AMENDMENT #1 TO SP-II LOWER HILL PLANNED DEVELOPMENT DISTRICT  
PRELIMINARY LAND DEVELOPMENT PLAN (AS APPROVED DEC. 2, 2014)

# Amendment #1

This Amendment #1 to the SP-11 Lower Hill Planned Development District modifies courtyard standards, adds a new building frontage type (Type G), and modifies street frontage requirements. The applicability of this Amendment #1 is limited to Block D.

FIGURE 1.1 Frontage Type G

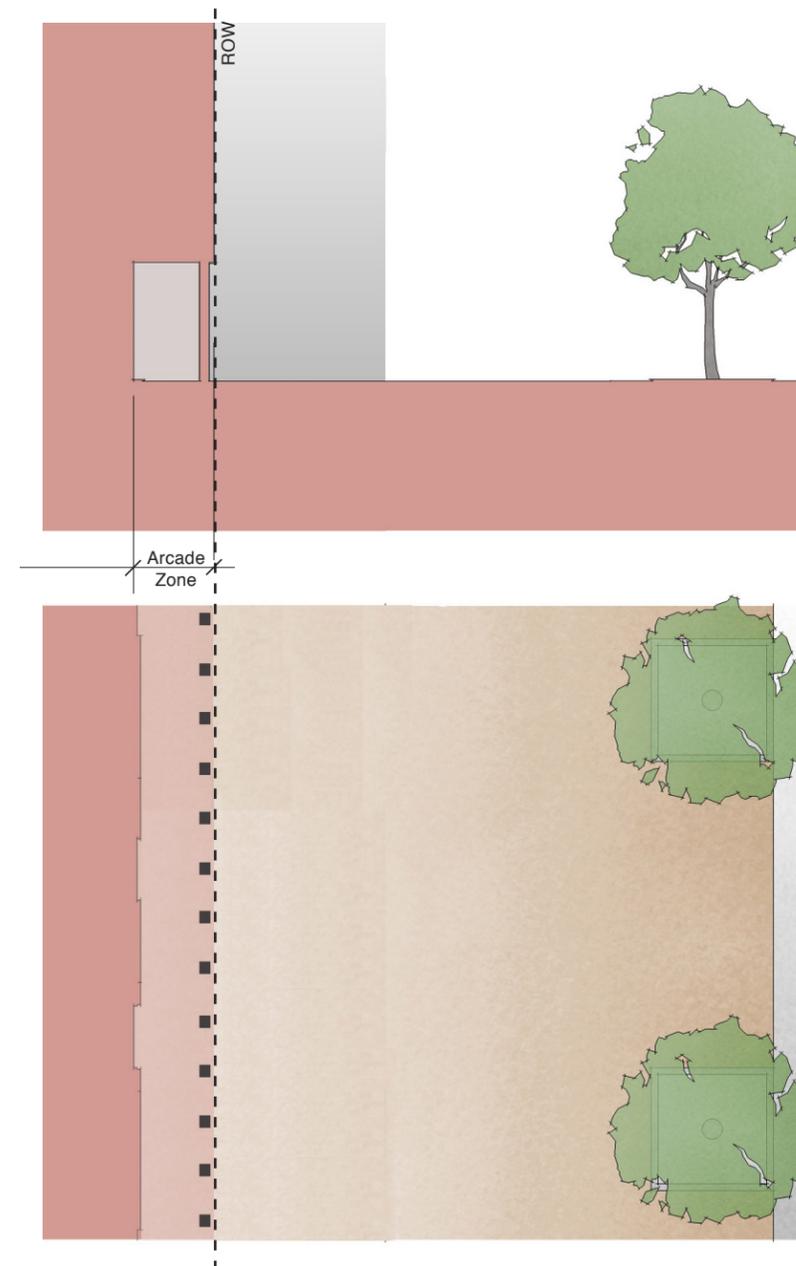
The following frontage type is added to the frontage types included on Page 21, Section 2.7.1:

### Ⓒ Commercial Frontage Type: Arcade

A frontage where the building is setback from the sidewalk a distance that is greater than the setbacks otherwise permitted in Frontage Type E and Frontage Type F, provided that an overhead building element (such as an overhang and/or upper level story) extends to the sidewalk edge or beyond (if permitted pursuant to an encroachment permit, if required). This frontage type may include columns that extend from such overhead element to the ground. The specific dimensions of arcades may vary, yet in all cases when used as a pedestrian pathway it must meet ADA and applicable code requirements.

FIGURE 1.2 Street Frontages Regulating Plan

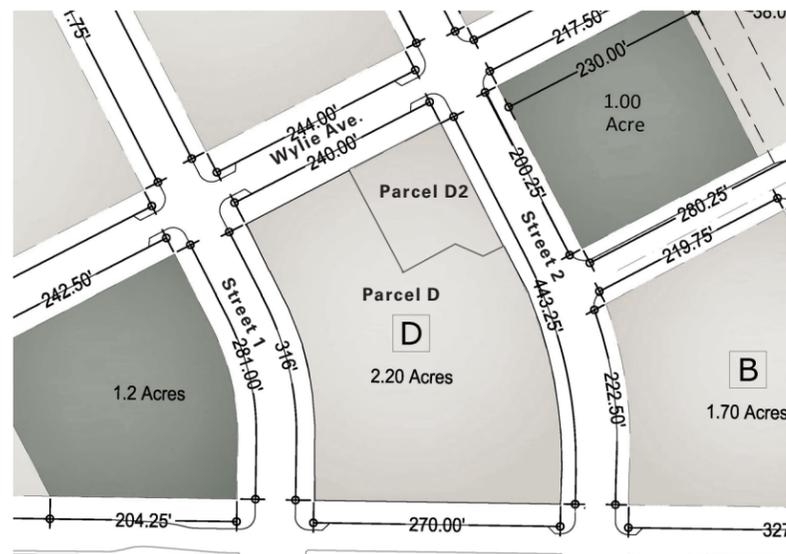
The Street Frontages Regulating Plan shall be modified for Block D to include the Arcade Frontage Type in the locations as depicted in Figure 1.2 herein.
